# DARDEN CLEAN ENERGY PROJECT

## Updated Staff Assessment

# **UPDATED STAFF ASSESSMENT**

## **Darden Clean Energy Project**

Page 5.2-5 of the Staff Assessment

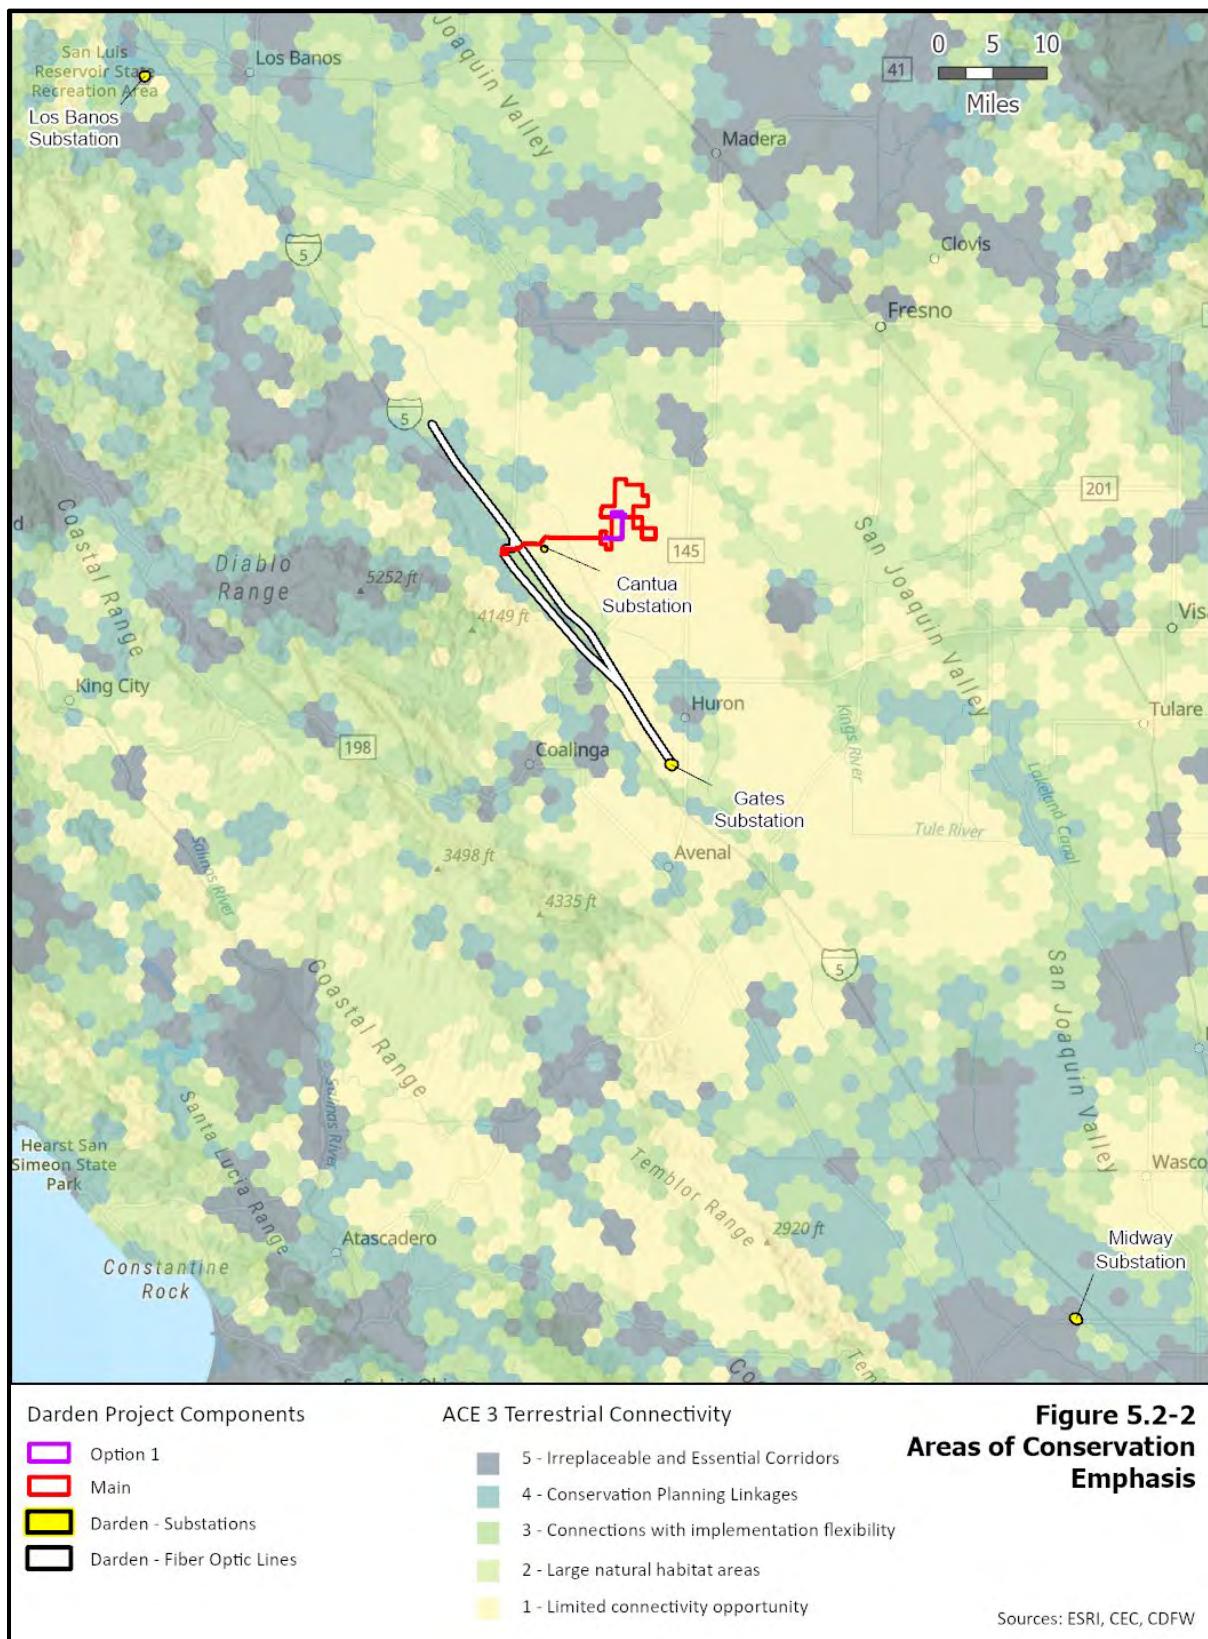
**Comment on Green Hydrogen Removal pg. 5.2-10; figure 5.2-2**

**Response to 11-30.** Staff agrees with the comment and proposed changes. In response to the applicant's comment, please see revised **Figure 5.2-2**. The revised figure is provided in **Section 3, Revisions to Staff Assessment**, page 5.2-10.

Additional details on land cover are documented in CEC **Supplemental Data Request** Response Set **41** in Table 2 **(RCI 2024ww)** and Appendix E (RCI 2024u) and mapped in the application as Figure 5.2-5 (RCI 2024u) as well as in Appendix A to CEC Data Request Response 6, as REV 1 DR BIO-1 Updated Land Cover Maps (RCI 2024z).
